UNITED STATES ENVIRONMENTAL PROTECTION AGENCY
REGION IX
75 Hawthorne Street
San Francisco, CA 94105

March 8, 2001

Re: U.S. EPA Review of Draft Remedial Investigation Report for Operable Unit 4A (IR Site 2-
West Beach Landfill/Wetlands) Alameda Naval Air Station

Figure 6-7. AREAS OF SUSPECTED HAZARDOUS WASTE DISPOSAL, WEST BEACH LANDFILL (SITE 1), NAS ALAMEDA

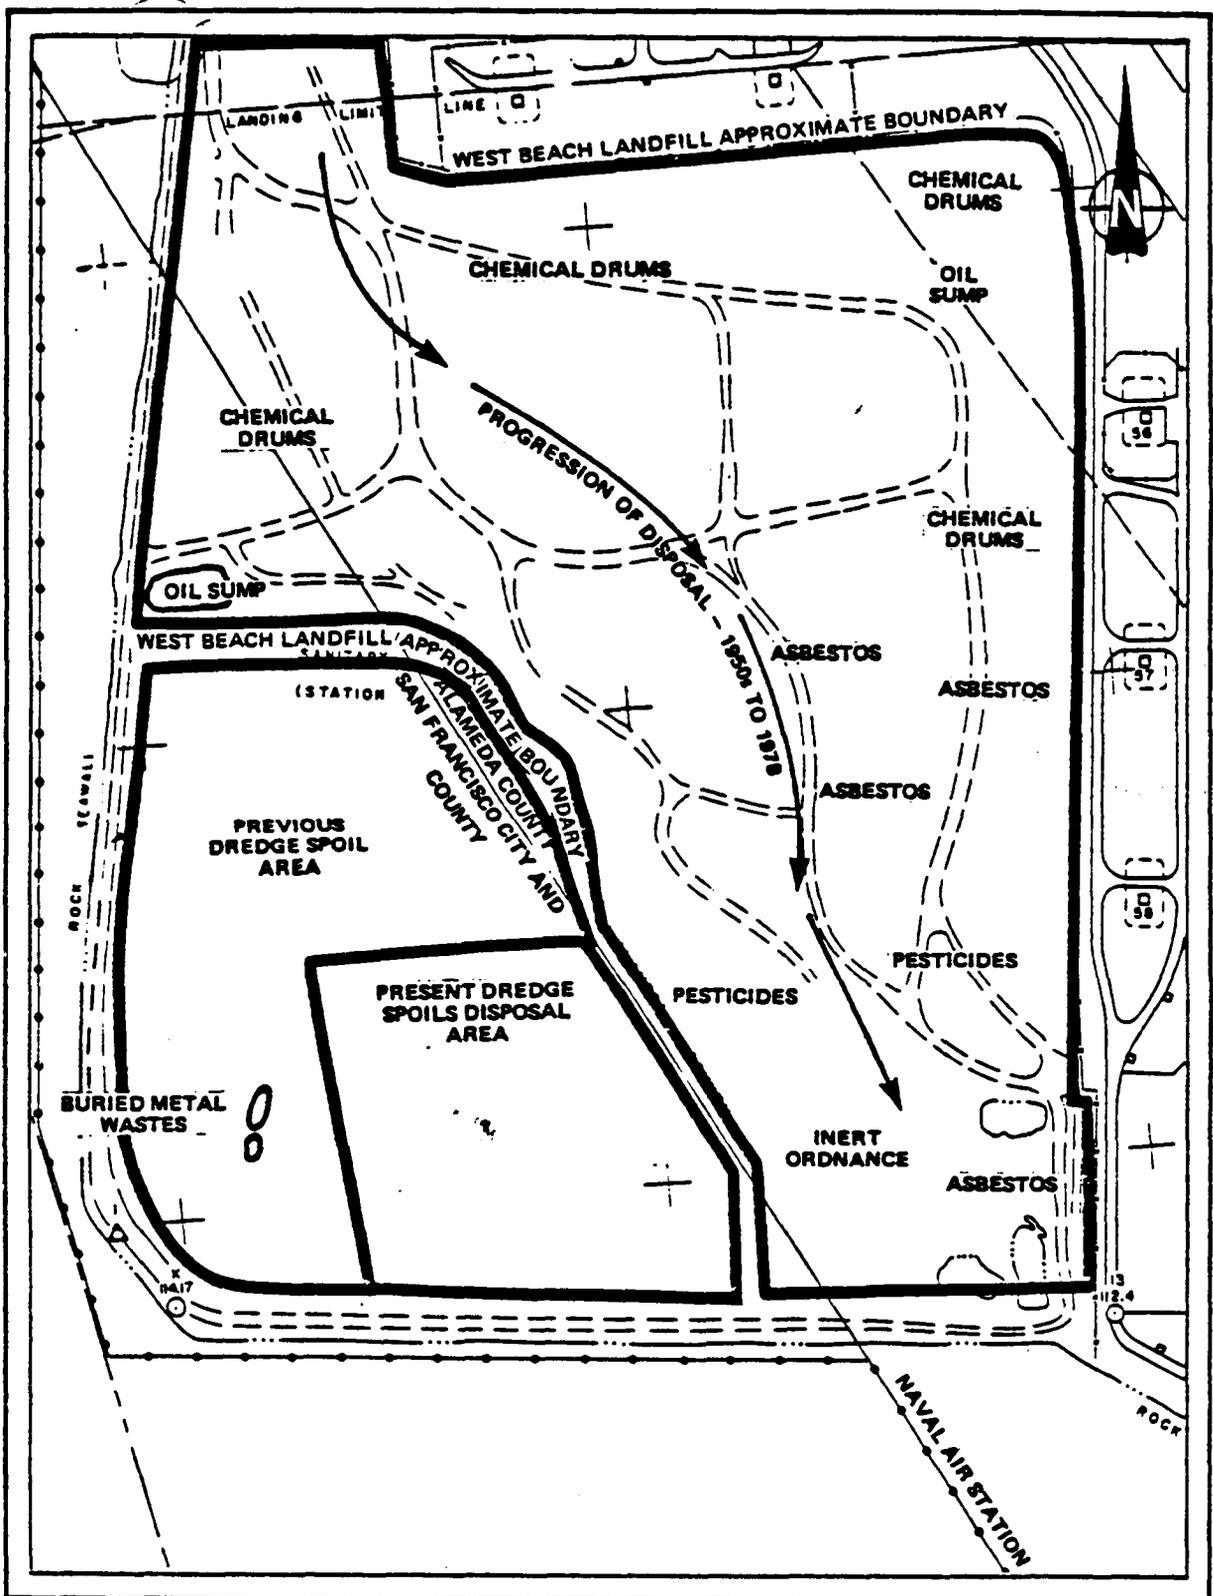
5. Site audit information documenting disposal of radiological, chemical, and UXO hazards needs careful re-evaluation. The Navy should research and review all existing documentation regarding waste disposal activities. As indicated above, U.S. EPA has recently received an Initial Assessment Study, that provides information on disposal practices (NEESA 13-014, 1983). U.S. EPA has identified a key figure from the NEESA study, Figure 6-7 (Areas of Suspected Hazardous Waste Disposal, West Beach Landfill...). This figure identifies “chemical drums, inert ordnance, pesticides, asbestos, oil sumps, buried metal wastes, and dredge disposal areas”. A similar figure also appears in the Navy’s *Final Unexploded Ordnance Site Investigation Survey Work Package Operable Unit (OU) #3* [which at the time also included the West Beach Landfill] *Alameda Point Alameda, California*, May, 1999. The subject figure, from the 1983 Initial Assessment Study, is included as Enclosure B.
